**BLYTHE ENERGY PROJECT**

**Request for Staff Approved  
Project Modifications  
(99-AFC-8C)**

**Blythe Energy Project  
Transmission Line**

**Southern California Edison's Blythe Eagle Mountain  
Transmission Line Pole Relocations and Modifications**

**Figure 2-2**  
Comparison of Existing and Replacement  
Edison Structures

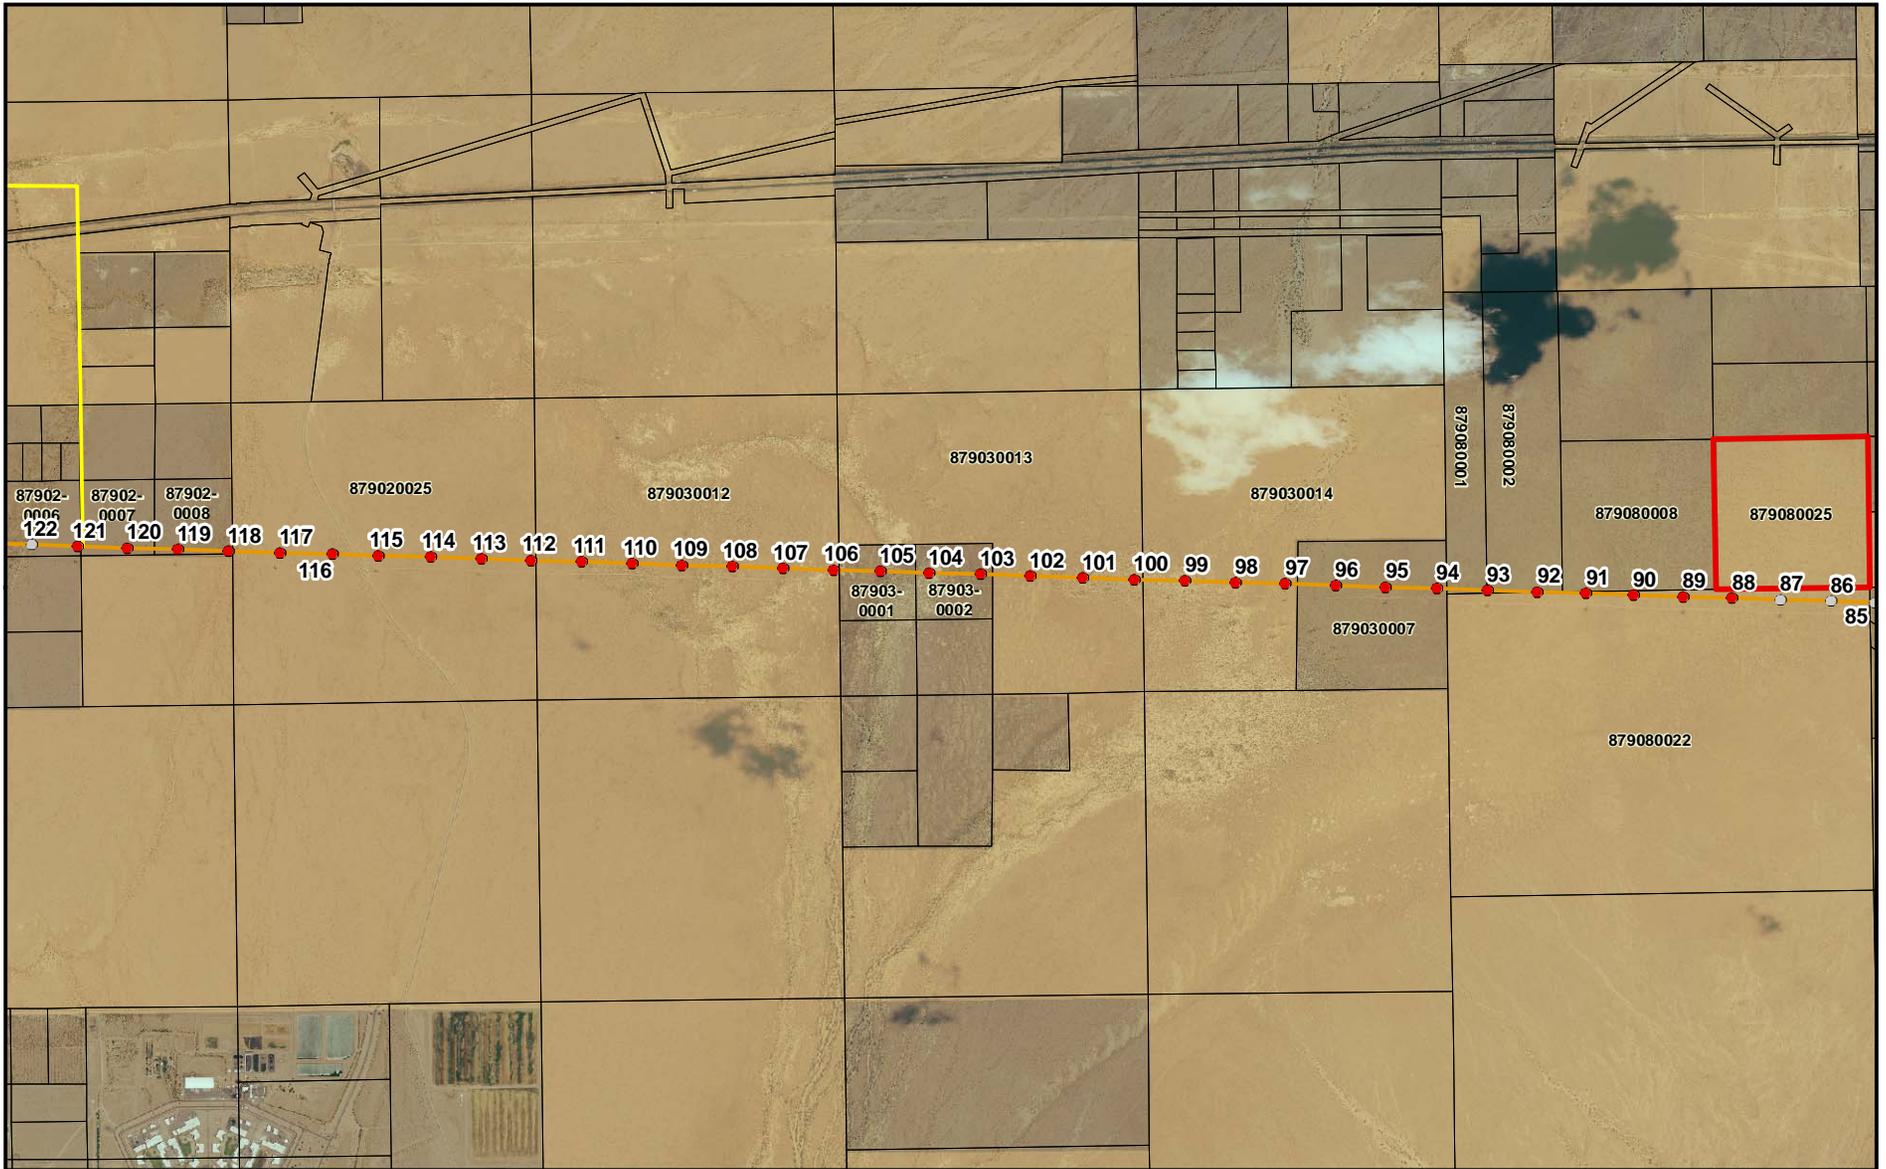
Figure 2-1 shows the present locations and proposed locations of structures 124605 and 179065E/1795066E of the B-EM transmission line to be relocated to accommodate crossing by the BEPTL. Appendix B details the structure changes and locations. Structure 124605 is currently located on the east side of the BEPTL just north of BEPTL structure 6, adjacent to the power plant property. It will be relocated approximately 190 feet to the west, on the existing alignment. The existing structure is a 90-foot wood pole H-frame with an above ground height of 79 feet. The replacement structure will be a 110-foot steel pole H-frame with an above ground height of 90 feet. This new structure will be supported by three way guys anchored 85 feet from the poles (west, north, and south) and a span guy on the east over the crossing of the BEPTL.

Figure 2-4. Comparison of Existing and Replacement Structures.

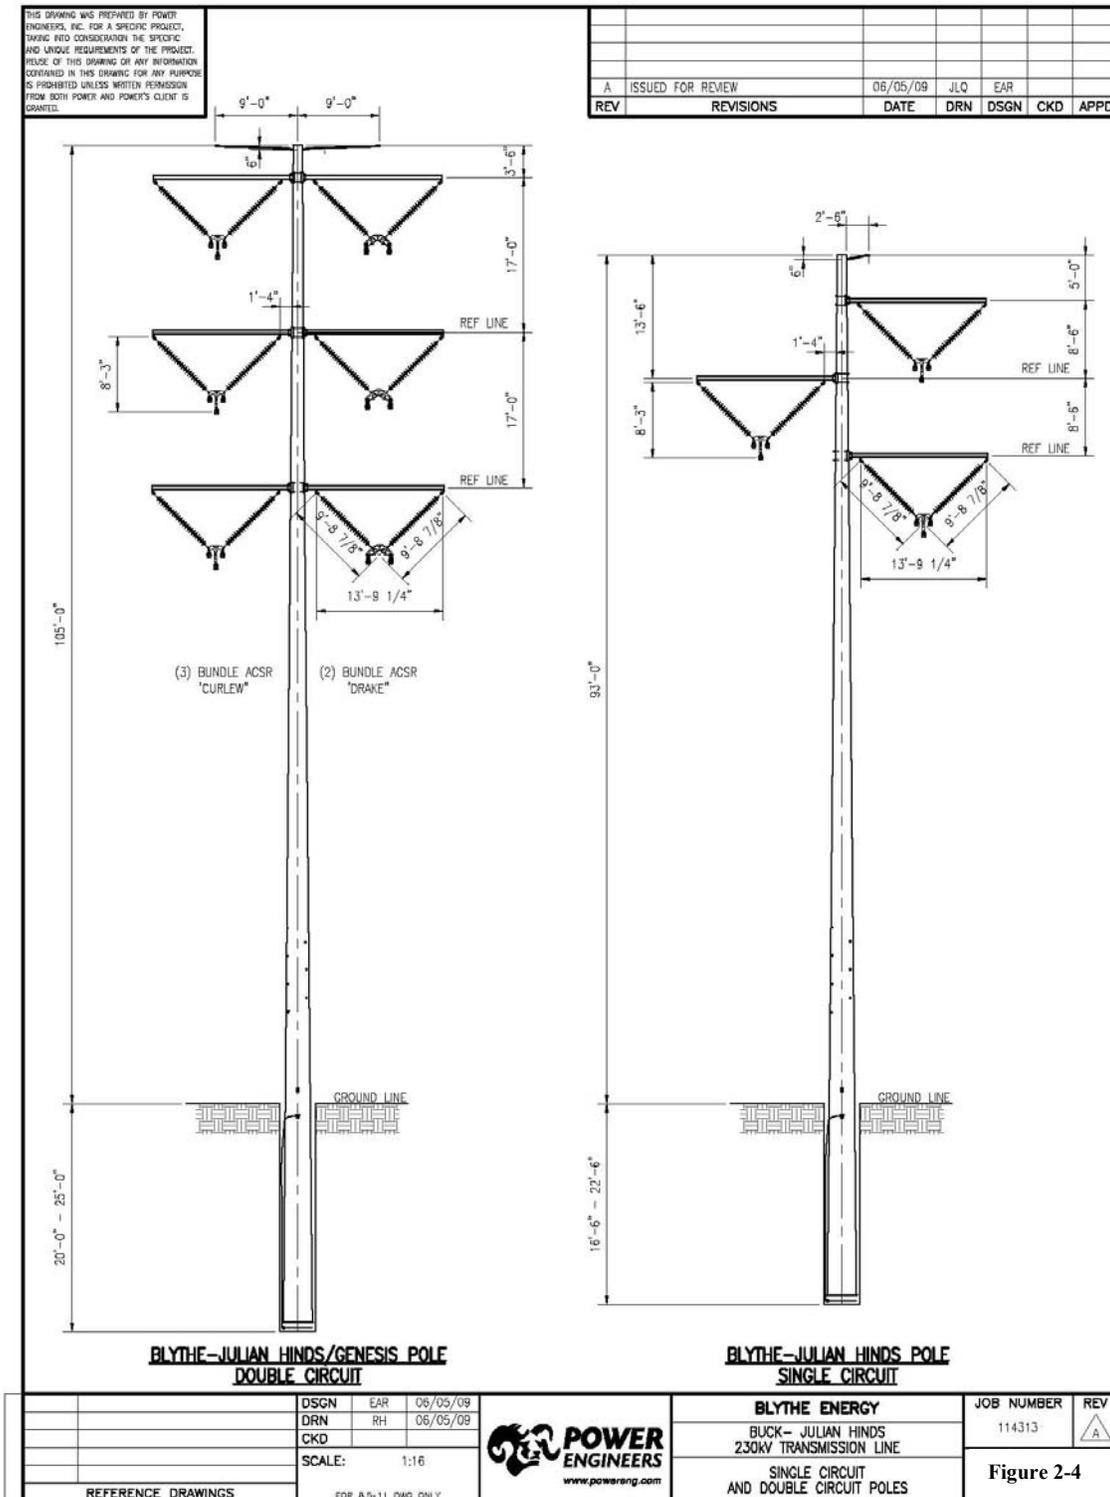
Figure 2-2 shows the locations of the BEPTL structures proposed for removal and replacement. Structures 88 through 121 cover 5.5 miles in a straight east-west line, with Project Genesis' proposed intertie line departing the BEPTL at structure 121 and heading northwest towards Ford Dry Lake. The existing structures are 105- to 115-foot concrete poles with an above ground height of 88 to 102 feet. The replacement structures will be a 125 to 130-foot double circuit concrete pole with an above ground height of 105 feet. These new structures will be self-supporting, direct-embed poles, please see Figure 2-4 for a comparison of the structures.

A new double-circuit-ready concrete pole would be delivered by a pole truck to the pad. On the pad, the insulators, hardware, and stringing sheaves would be installed on the pole and the pole would be lifted into position, inserted into the foundation hole and gravel and/or concrete would be poured in to backfill the hole and create a foundation. The entire process would take about 5 hours for each replacement.

**Figure 2: Showing Replacement For 124605**

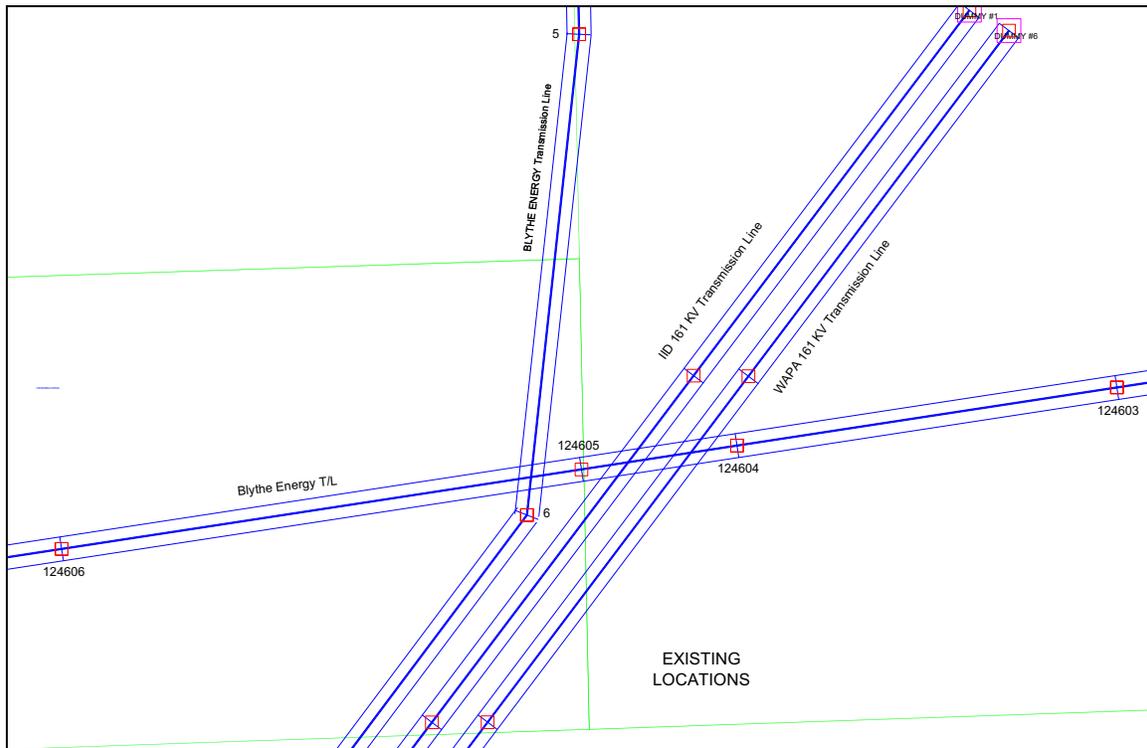
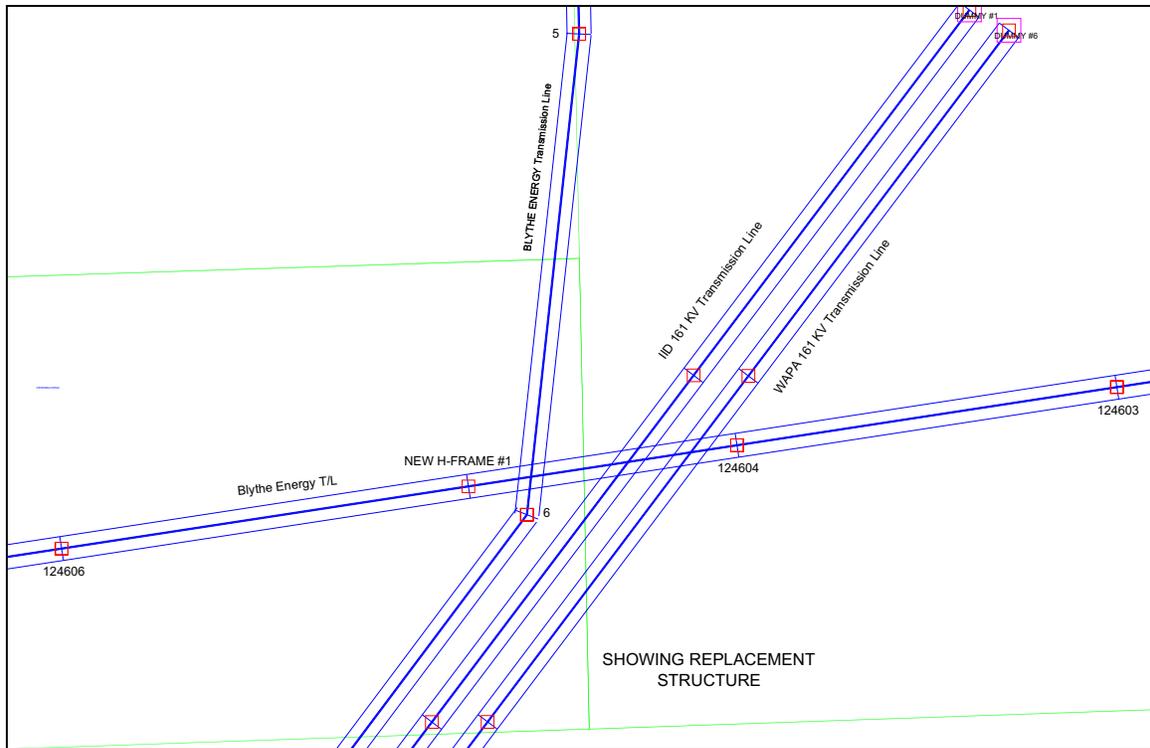
Figure 1 shows the present location of structure 124605 on the Blythe Eagle Mountain (B-EM) line relative to the Blythe Energy Transmission Line (BETL). The BETL turning structure shown below is structure 6 and is adjacent to the power plant property. To accommodate this crossing and allow for future maintenance of the SCE structure requires that it be relocated to the west on the existing alignment by 190 feet. The existing structure is a 90 foot Wood Pole H-Frame structure with the top of pole approximately 79' above the ground (see the attached drawing). The replacement structure will be a geometrically similar 110 foot steel H-Frame with the top of pole 98 feet above ground surface. Its location is shown in Figure 2.

1. Installation of New H-Frame with three way guying in place of 124605 but 190 feet to west.
2. Install a replacement steel H-frame of the same configuration but 5' taller at existing location of 124604.
3. Move conductor to new structures. Replacement of suspension hardware at structure 124606 with dead ending hardware. Ahead and back guying of this structure will be required.
4. Remove existing structure 124605.
5. Change suspension hardware on 124603 to dead end hardware and add back and ahead guys.

**Figure 4: New Freeway Crossing Structure Location**

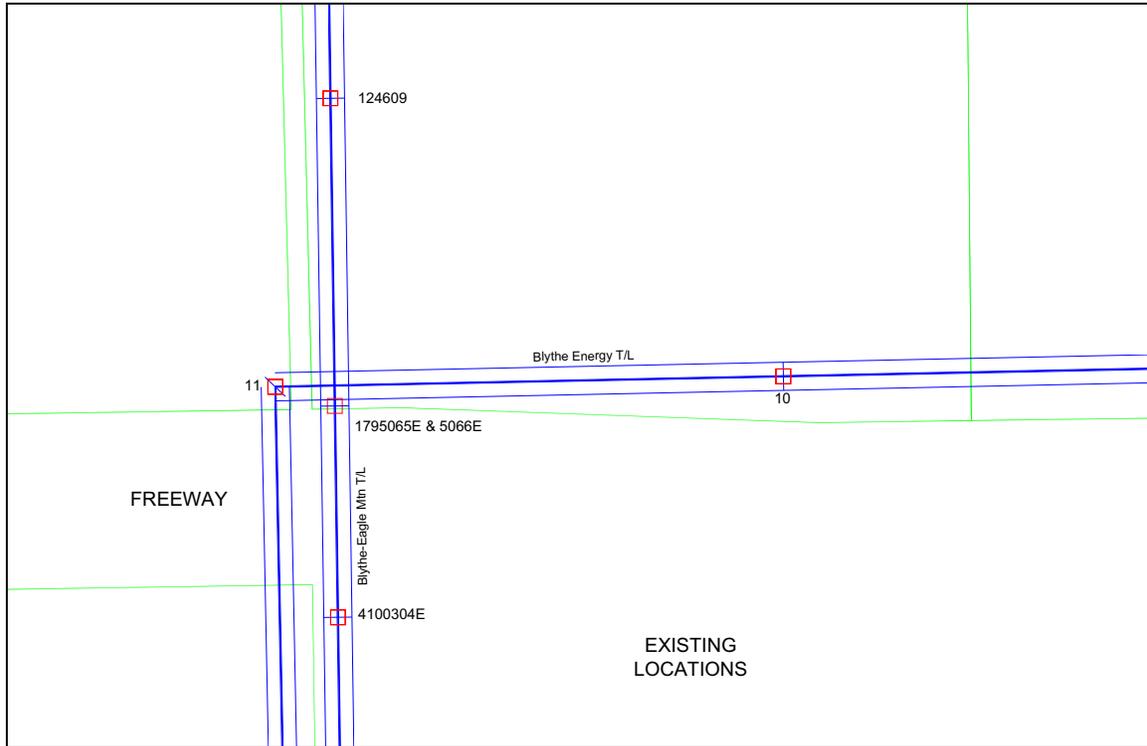
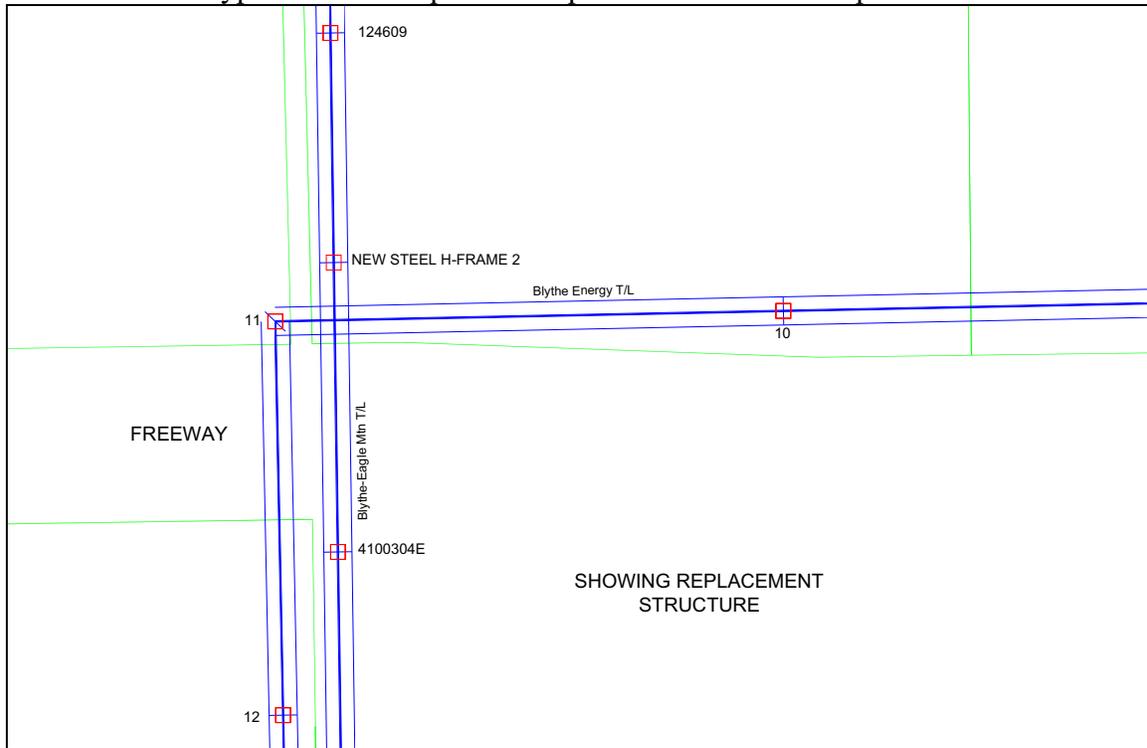
The existing SCE structure on the north side of the freeway crossing is a wood pole H-frame with suspension hardware (see attached drawing 438968). The poles are 75 foot long with an above ground height of 66 feet. The replacement structure will be geometrically similar but constructed of steel poles and top of poles will be 71 feet above the ground. The taller structure will necessitate changing hardware on the next structure north to dead end hardware and add back and ahead guys to it (structure 124609 on the Figures).

1. Installation of the New H-Frame 106' north of existing structure 1795065E/1795066E.
2. Installation of 80' H-frame at locatin of structure 4100304E south of the freeway.
3. Attach wires to new structure.
4. Remove existing structures.

5. Replace hardware on 124609 and add guys to north and south.
